P 523648

A REPAIR

ON-SITE SEWAGE DISPOSAL SYSTEM HOWARD COUNTY HEALTH DEPARTMENT BUREAU OF ENVIRONMENTAL HEALTH

ADDRESS: 10822 Braeburn Road PROPERTY OWNER: James Williams

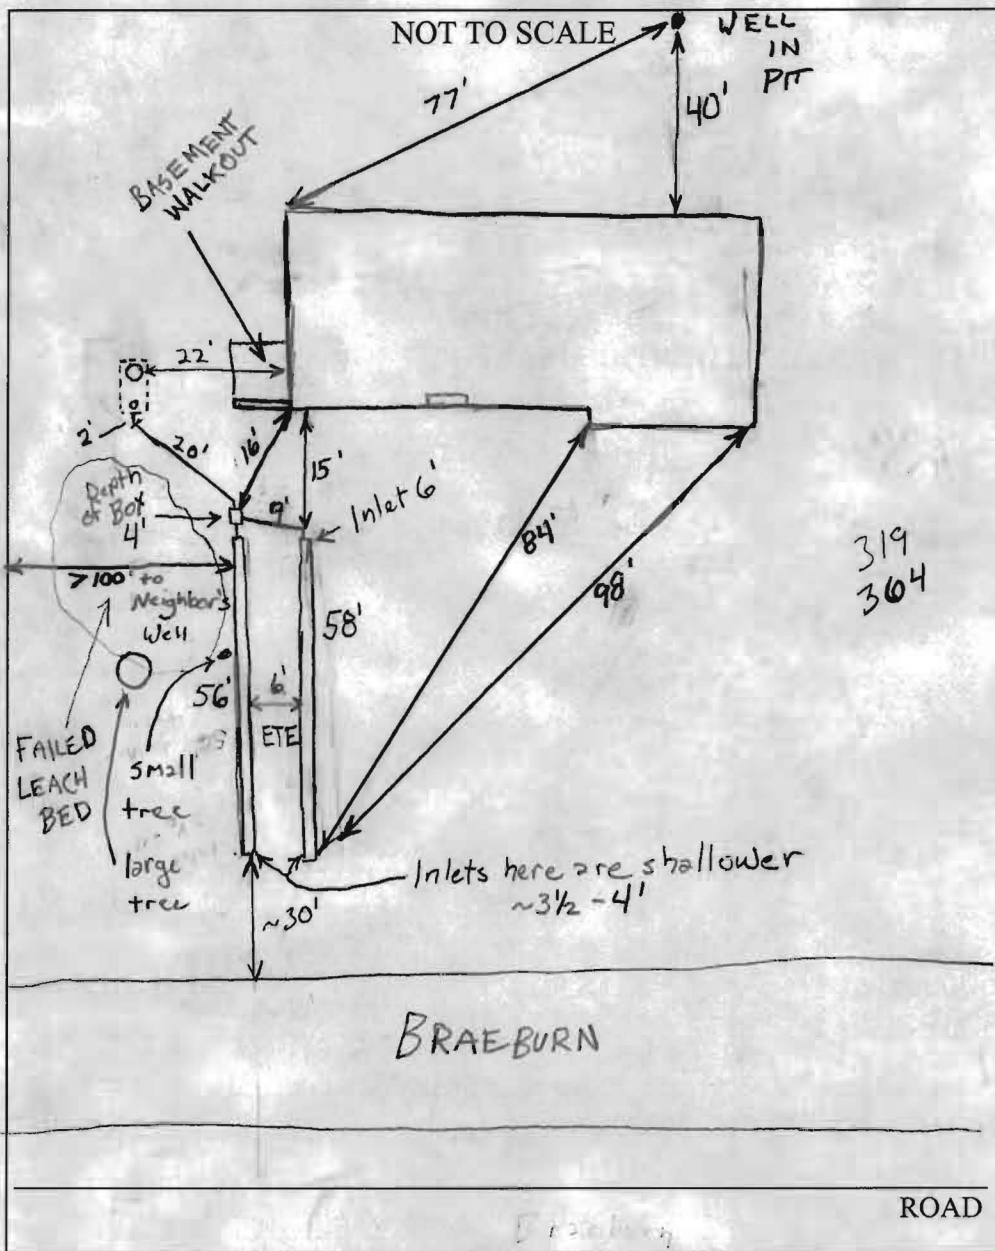
PRE-CONSTRUCTION 2 trenches installed along w/ new line from
 INSTALLATION Septic tank and Distribution box - trenches are running
directly through perched area, Trenches not quite on
contour but inlets are deep enough that this won't be a problem.
OK to cover. Told Robert Fyock to raise lid on manhole ~3"
or so to bring it above grade due to topographically low location
of tank in man-made swale or basement walkout. (GAC)

TRENCHES:	Trench to be _____ feet wide. Inlet _____ feet below original grade. Bottom maximum depth _____ feet below original grade. Effective area begins at _____ feet below original grade. _____ feet of stone below distribution pipe.
LOCATION:	<u>Raise Manhole Cleanout on Tank, Future Repairs Will Require Pump</u>
PURPOSE:	Existing septic system has failed. Call for inspection when ground is opened so sanitarian can recommend repair.
